**From:** [REDACTED]  
**Sent:** 2025-07-29 星期二 18:23:29  
**To:** Shirley Ka Kei CHAN/PLAND <skkchan@pland.gov.hk>  
**Subject:** RE: A/NE-FTA/261 - departmental comments  
**Attachment:** Comments from the TD Department.pdf; DD52 188 D.G.STORE  
HGV SWEPT PATH (TD-01).pdf; DD52 188 D.G.STORE PRIVATE  
CAR SWEPT PATH(TD-02).pdf

**Response to the Comments from the Commissioner for Transport (Contact Person: Mr. TAM Kam-fai, Tel. 2399 2405)**

Leo

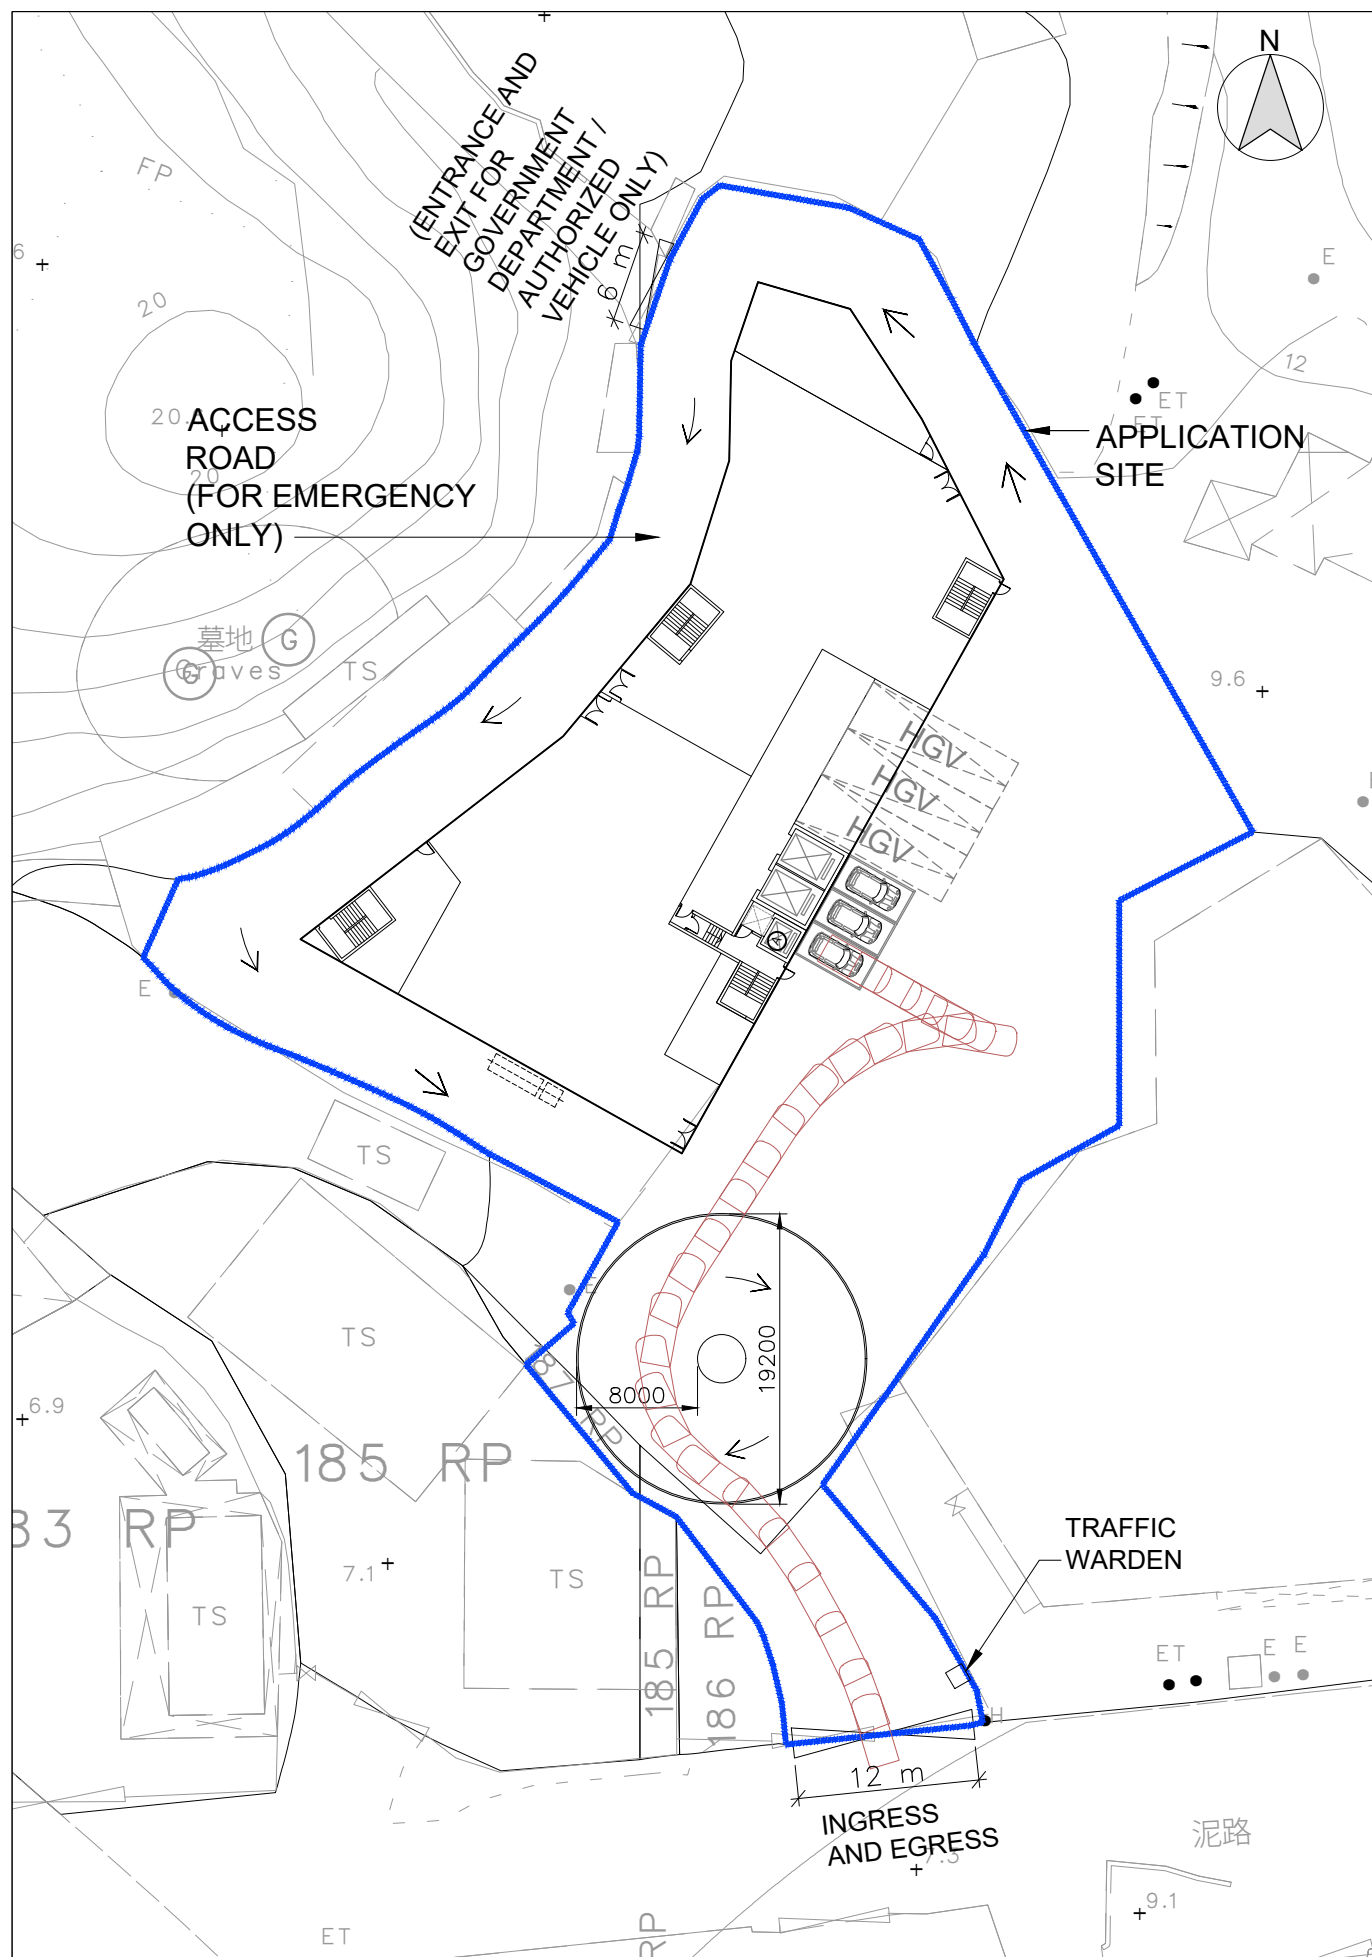
- (i) The applicant should justify the adequacy of the proposed 6m width of the ingress and egress points for vehicular access;  
出入口擴闊至 12 米(請參閱 TD-01 及 TD-02)

- (ii) The applicant shall demonstrate the satisfactory maneuvering of the goods vehicles entering and exiting the subject site, maneuvering within the subject site and into/out of the parking and loading/unloading spaces, preferably using the swept path analysis;  
附上掃掠路徑分析圖(Swept Path Analysis)(請參閱 TD-01 及 TD-02)以顯示貨車足夠進出停放和裝卸空間, 以供參考。
